Authors' responses to B. MacVicar (Referee #1)

Authors' responses to Anonymous Referee #2

This paper studied the channel widening and LW dynamics through a post-event survey carried out after a large flood in a mountain river basin in Switzerland during the summer 2014. After detailed statistical analysis the authors find out control factors for the studied phenomena, among which they highlight the precipitation. The paper is well written and structured and presents a solid methodology and the results presented in this paper are highly valued to better understand this kind of phenomena. The kind of data presented in this paper are highly valuable because, as commented in the paper, the data are still scarce and relevant for river management. Therefore, I suggest the paper to be published. However, I have few comments that I hope help the authors to improve the present manuscript and make it clearer for the reader. These comments are divided in sections.

Figure: Boxplots of LW recruited (m^3/ha) and deposited volume (m^3/ha), stream power index and unit stream power calculated with the estimated discharge and the initial channel width for small and medium watersheds following the classification by Seo and Nakamura (2009).

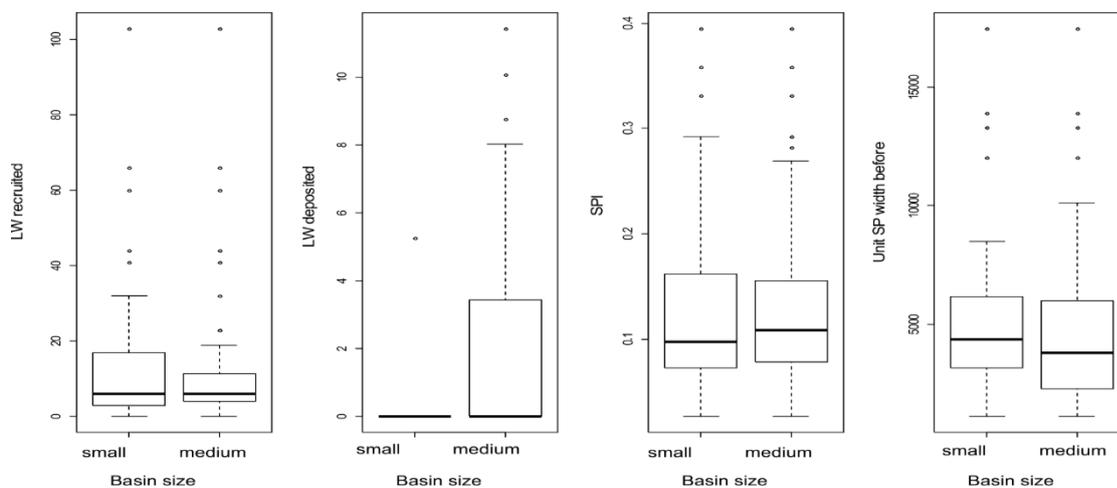
The second point is that I think the study provides an opportunity to test some conceptual models such as that of Seo and Nakamura (2009) where they separate channels into different classes to explain differences in wood dynamics. It would be useful to understand whether this model holds for an individual flood and whether the morphologic variables used could be used to divide the channels into two or three classes rather than the rather arbitrary division used in the study of the Emme and everything else. Alternatively, the decision to group the channels as you did could be supported by using the conceptual model to justify the choice.

Authors' response: We thank the reviewer for this comment, and we appreciate the suggestion of bringing up new avenues of thought for considering our results. We considered Seo and Nakamura's conceptual model, but we unfortunately could not apply this model to our data. They observed that LW dynamics (in terms of LW recruitment, transport, storage, and fragmentation and decay) varied along the gradient of watershed size. They classified their data in three size groups, small (<20km²), medium (20-100km²) and large (>100km²) watersheds. A similar classification cannot be done with our dataset, as the largest watershed has an area of less than 100 km² (96km²). Still, we grouped our dataset in the two smaller classes, small and medium watersheds, but we could not find significant differences in the variables analysed by Seo and Nakamura. The following figure shows our dataset grouped by the watershed size:

We observed slightly similar trends to the trends in Seo and Nakamura in our data, regarding LW recruitment, which was much higher in the small watersheds (Emme tributaries) than in the larger watersheds (mostly the Emme subreaches and some larger tributaries), as it is shown in the figure above and in the Figure 7 in the manuscript. However, differences are not significant. LW storage was only analysed along the main stem of the Emme River and in two tributaries, so our dataset is not suitable to test the conceptual model proposed by these researchers. The same observation made for recruitment is also true for stream power. As the figure above shows, SPI (which is just based on drainage area and channel width) and unit stream power do not show significant differences between small and medium watersheds.

We added some discussion about that in the revised manuscript.
